ARTWORK APPROVAL

PSM/PSP – PSP-000-1965

AW006202 **Version 02**

ALGO TUBE GD MARIN FRAICHEUR 30ML 1120
(210727)

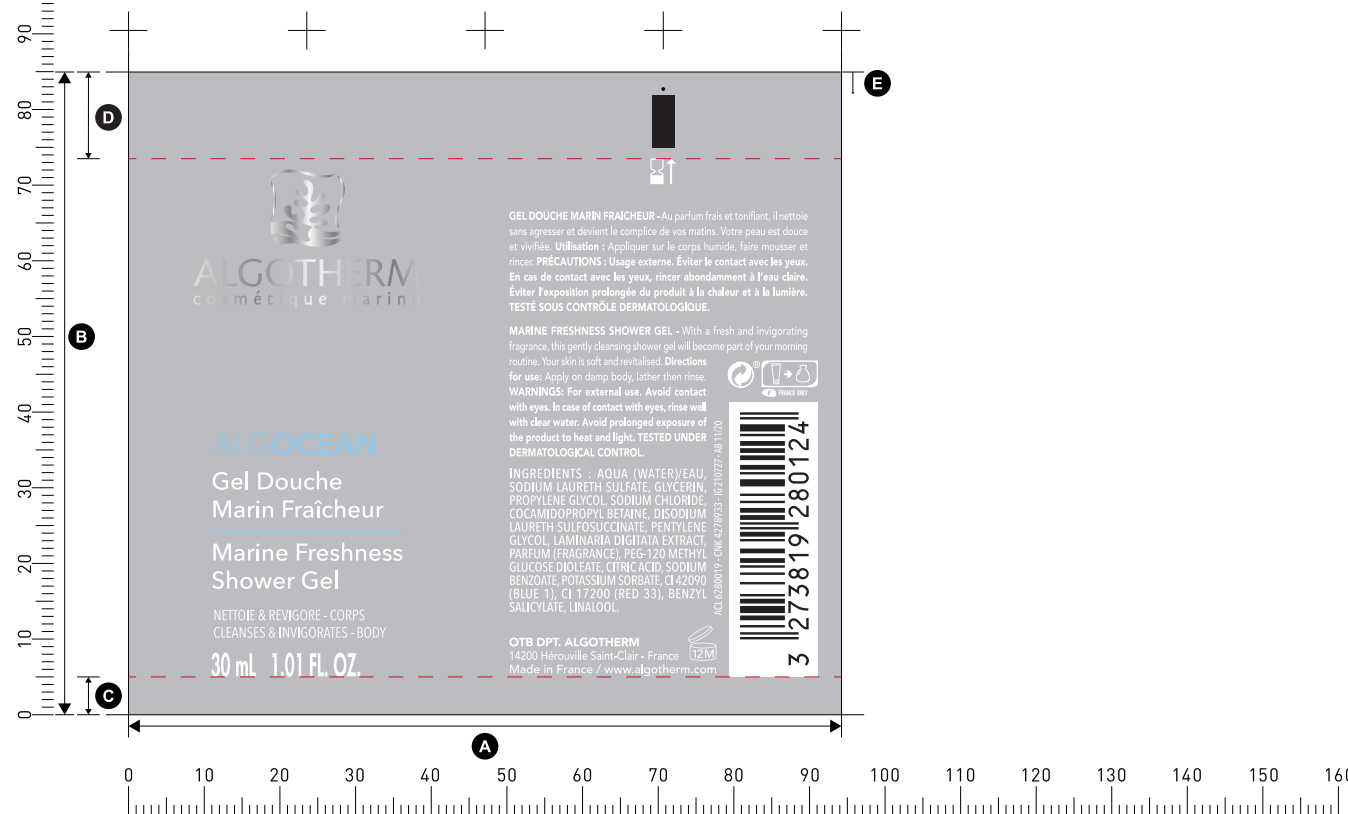
VER	DATE	COMMENT
01	28-12-2020	<ol style="list-style-type: none">1. As per received file we centre align both panel.2. Please note: On transparent sleeve white colour barcode sensing issue, So, We added one extra colour for barcode & eyemark.3. Please note: P 291 C light colour so after print readability issue because Substrate colour transparent.
02	05-01-2021	<ol style="list-style-type: none">1. As per received file we changed only on back panel.

Note:- "If no print at open end is less than 10MM there is chance of ink cracking while sealing of tube (depends upon colour of sleeve and ink), we suggesting there should be a sealing test before commercial printing"
